TECHNICAL BULLETIN

Ref Document No.	TB15005	Issue No.	1
Subject	Turbo Impacting on Methane Junction Box Mounts		
Release Date	20 th October 2015

Purpose – Advise COALTRAM® owners/operators of the possibility of the turbo impacting with the methane junction box mounts.

Applicability – All in service COALTRAM® models CT08, CT10 and CT10LP.

Figure 1

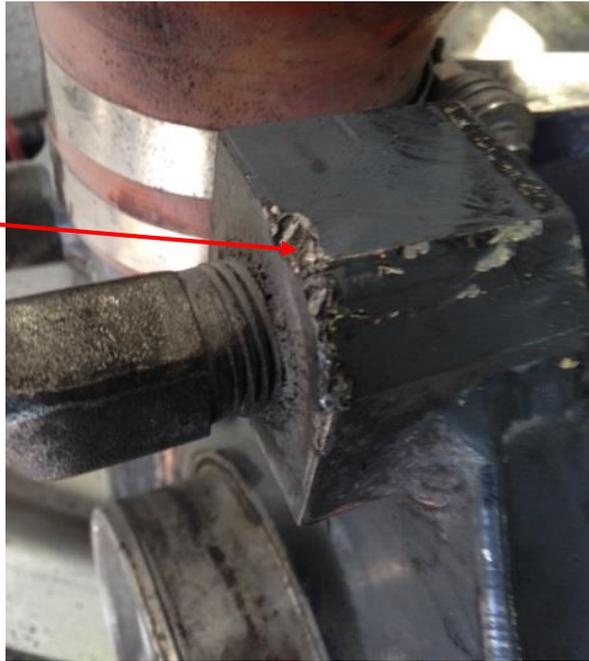
Impact marks were found on the turbo inlet snail water jacket. From the turbo's close proximity to the methane flameproof box mounting bracket it was determined that it had been frequently coming into contact with the nut and bolt that secure the methane system flameproof box to its mounting bracket (see Figure 1 and 2 below).

Impact marks on turbo water jacket

The impacts have been caused by the proximity of the methane flameproof box to the turbo. The engine mounts allow some movement of the engine to absorb vibration and engine torque. The resulting movement has allowed the turbo to impact with the methane flameproof enclosure. The engine mounts were inspected and deemed to be in an acceptable condition.

It is believed that the impact between the turbo and the mounting bolt and nut caused additional unforeseen stress on the joint causing the studs to come loose.

Figure 3: Riser plates installed

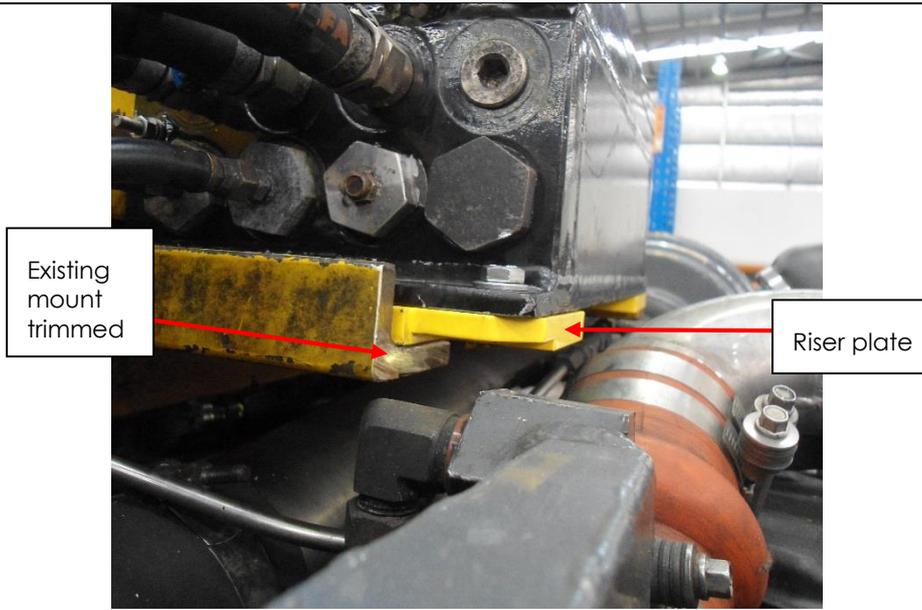
PPK has designed a retrofit modification to the methane system box bracket to create more room between the turbo and the bracket and fasteners. The modification includes cutting away part of the mount, installing riser plates and installing a new cover because the junction box has been lifted. See figures 3 and 4 below.

1. PPK recommends Coaltram owners/operators inspect their Coaltrams at the next available service for impact between the turbo intake water jacket and the methane system flameproof box bracket and securing fasteners.
2. If there are impact marks present between the turbo water jacket and mount bracket or fastener, or the gap between them is 10mm or less PPK recommend carrying out the modifications as shown above at the next convenience.
3. If the turbo is impacting on the fastener only, the fastener should be removed until the riser plates can be installed.
4. Please contact your PPK service centre for the modification to be carried out if required, or follow SWP CT8.34 for the recommended installation procedure. Parts required: Methane cover (5520002654), methane riser brackets (5520009767 & 5520009768) and M8x25 bolts (4 off – 0147132503).
